US DEPARTMENT OF ENERGY
HANFORD WASTE VITRIFICATION PLANT

DESIGN CHANGE NOTICE

DCN - 0100 | REV 1 | PAGE 1 OF 18

DCN TITLE: THIS DCN-0100 SUPERSEDES "DCN-0096" & "DCN-0096 REV 1"

DETAIL J 119279

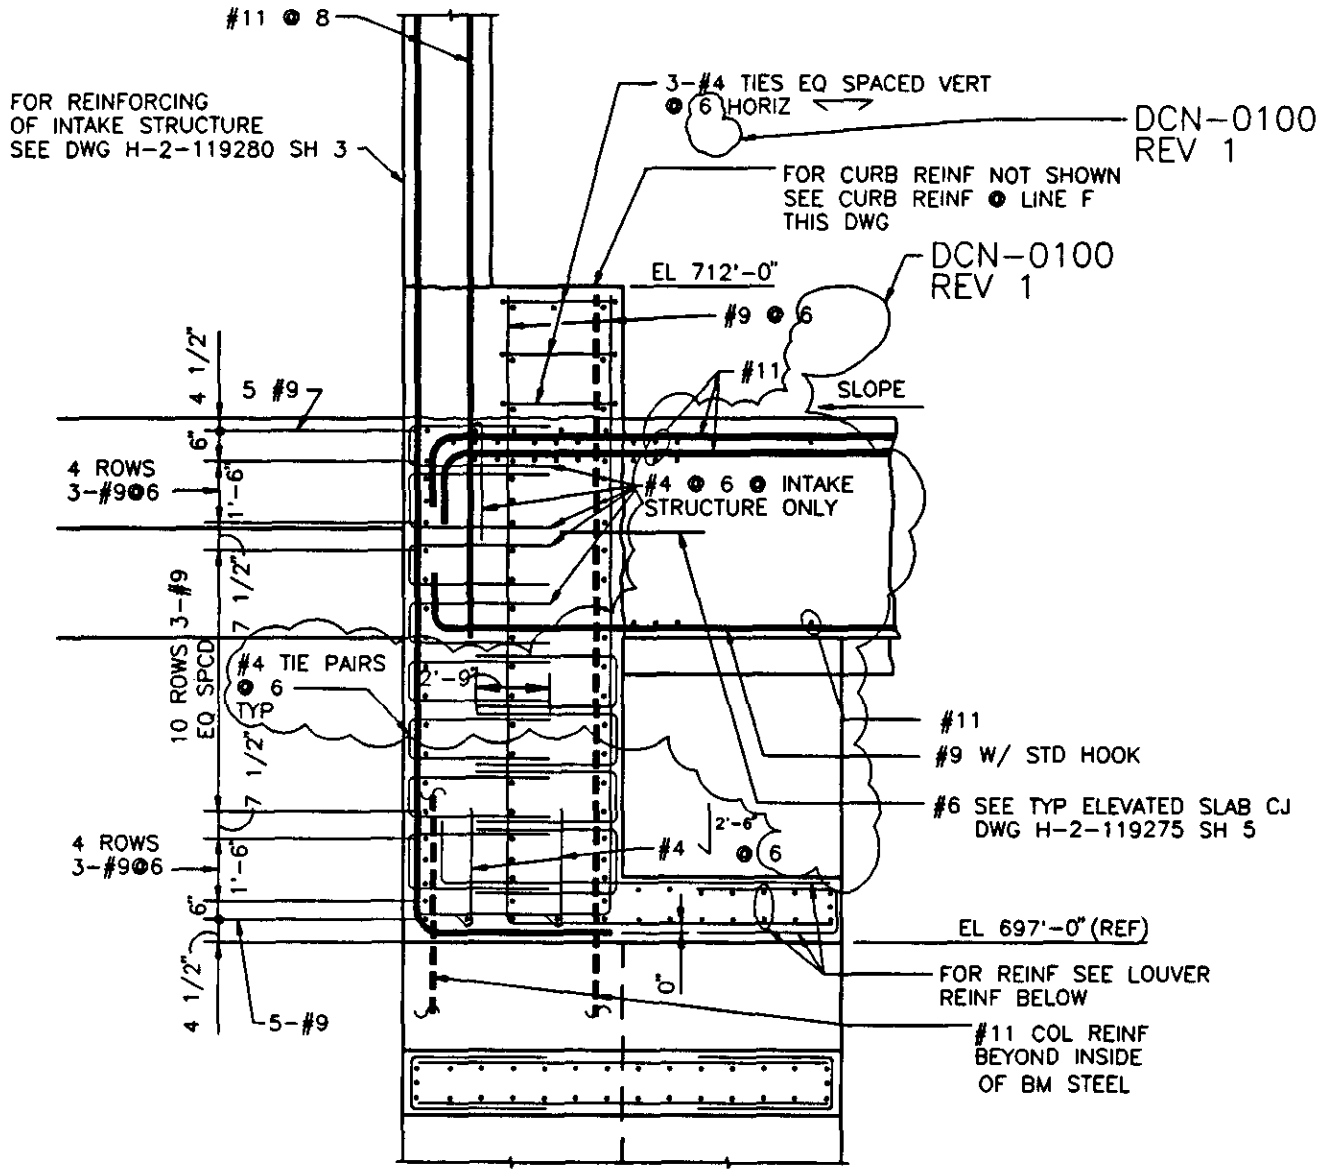
FLUOR DANIEL	U.S. DEPARTMENT OF ENERGY HANFORD WASTE VITRIFICATION PLANT	DESIGN CHANGE NOTICE
DESCRIPTION OF CHANGE: REMOVE HOLD HWVP-FD-364. REVISE REINFORCING SPACING AND TIE LAP DIMENSION		BASE DOC. NO. H-2-119285 SHT/PG. 1 REV. 2 CR NO. CR-HWVP-1025 DISCIPLINE: STRUCTURAL/DCN0096E
PREPARED BY: Amanda Tillman	DATE: 9/28/93	DCN - 0100 / REV. 1 / PAGE 16
DISCIPLINE ENGINEER: [signature]	DATE: 9/28/93

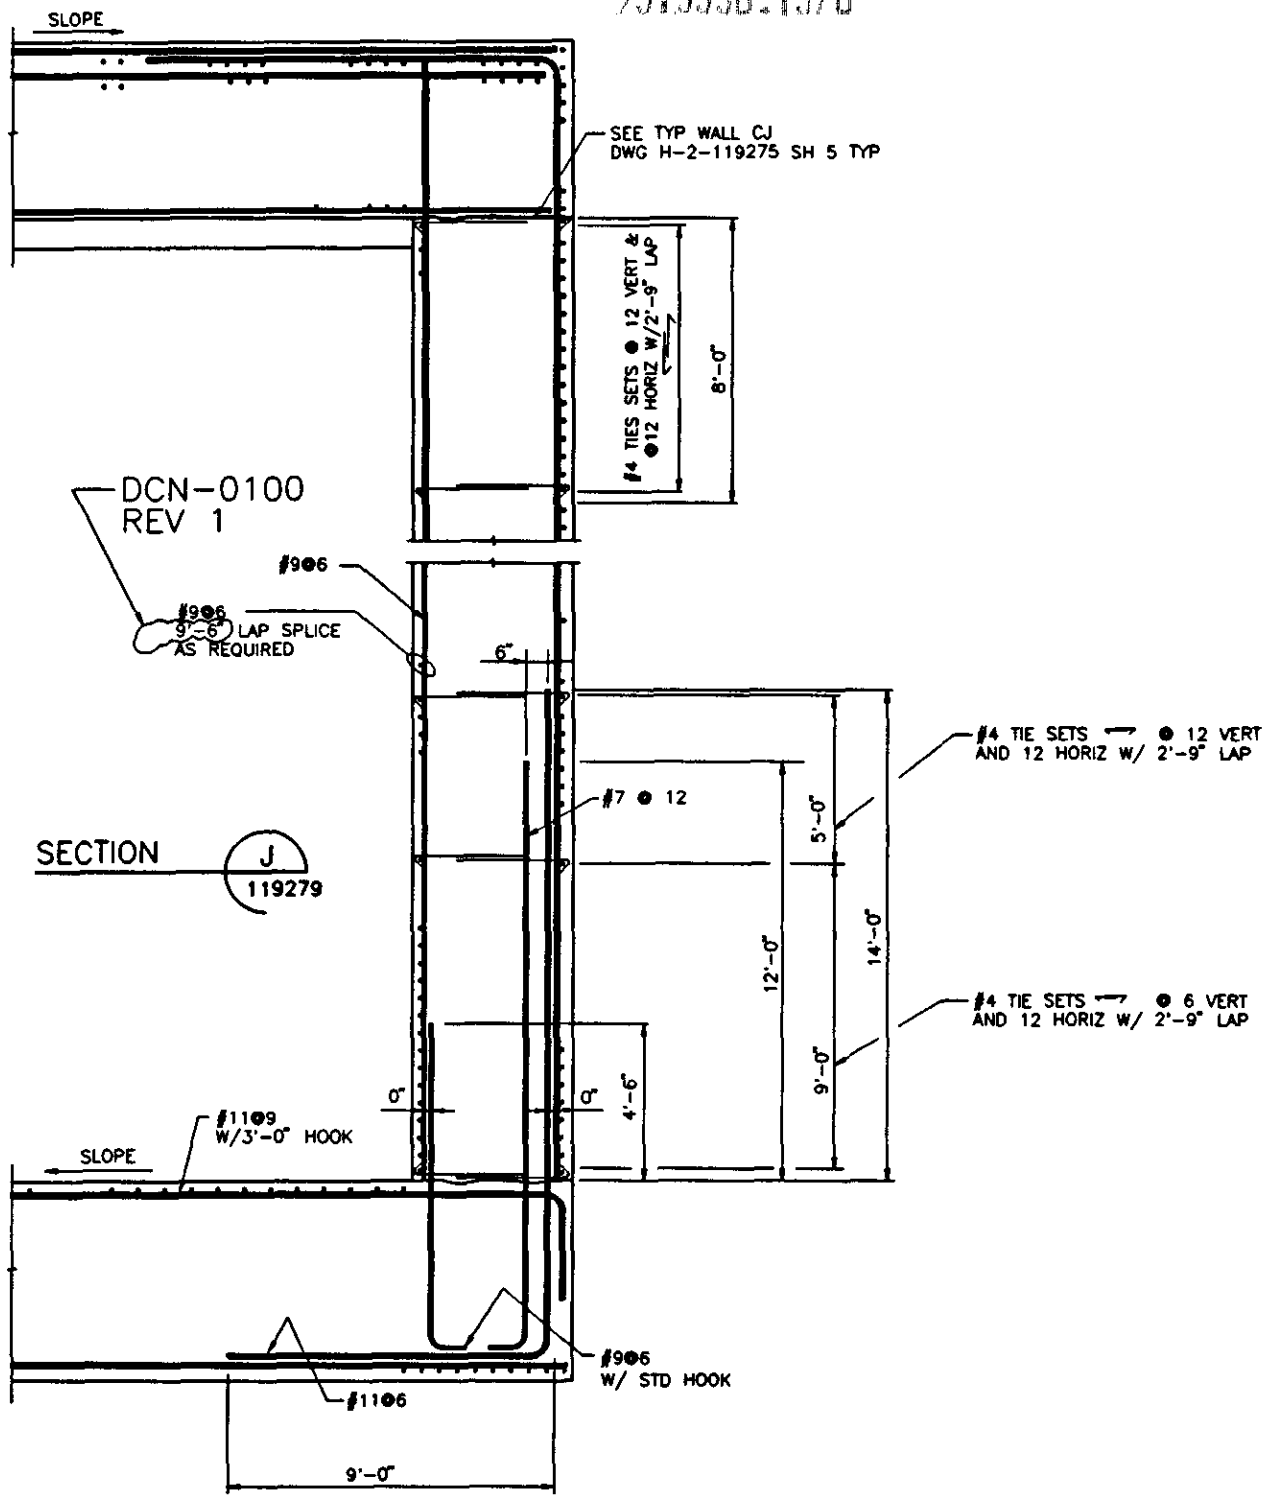
FLUOR DANIEL	U.S. DEPARTMENT OF ENERGY HANFORD WASTE VITRIFICATION PLANT	DESIGN CHANGE NOTICE
DESCRIPTION OF CHANGE: REVISE LAP SPLICE		BASE DOC. NO. H-2-119285 SHT/PG. 1 REV. 2 CR NO. CR-HWVP-1025 DISCIPLINE: STRUCTURAL/DCN0096L
PREPARED BY: Armando Villegas	DATE: 9/28/93	DCN - 0100 REV. 1 PAGE 17
DISCIPLINE ENGINEER: Robert A. Jones	DATE: 9/28/93

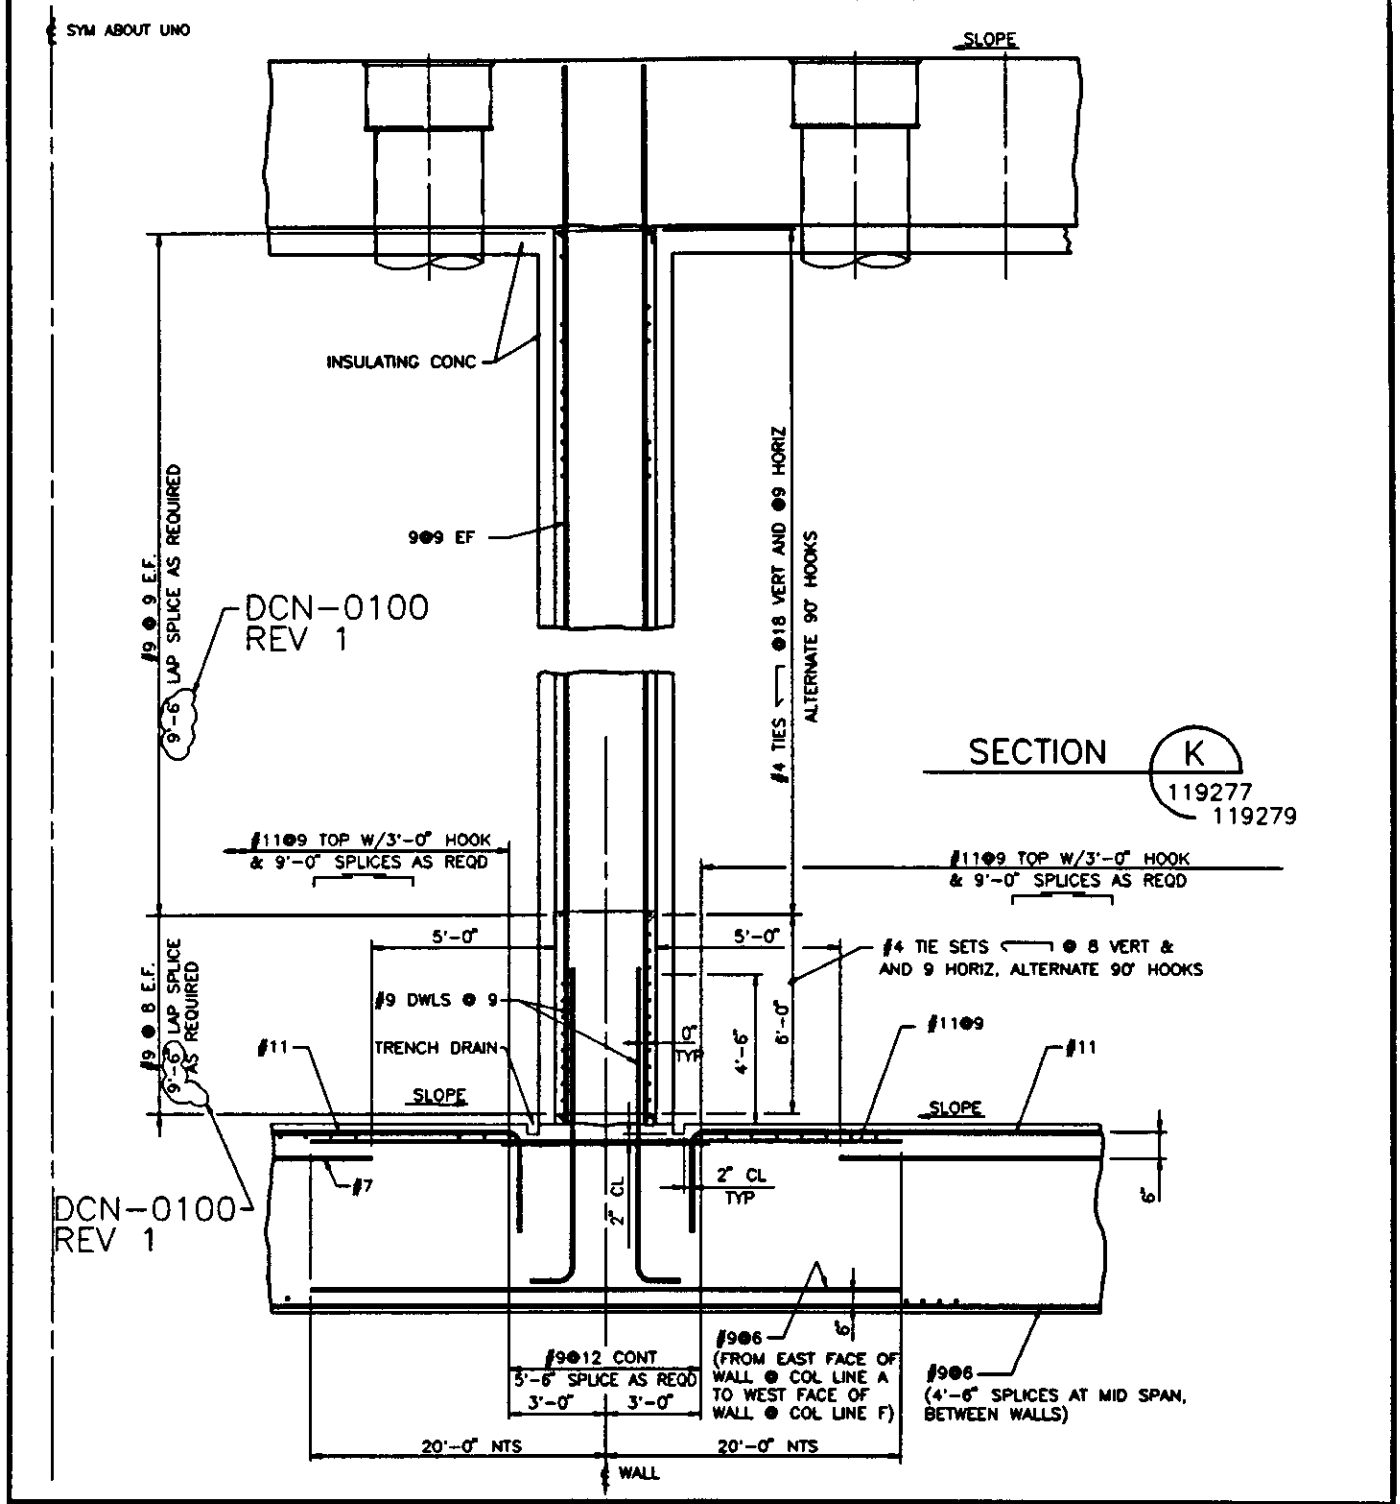
DESCRIPTION OF CHANGE: REVISE LAP SPLICE
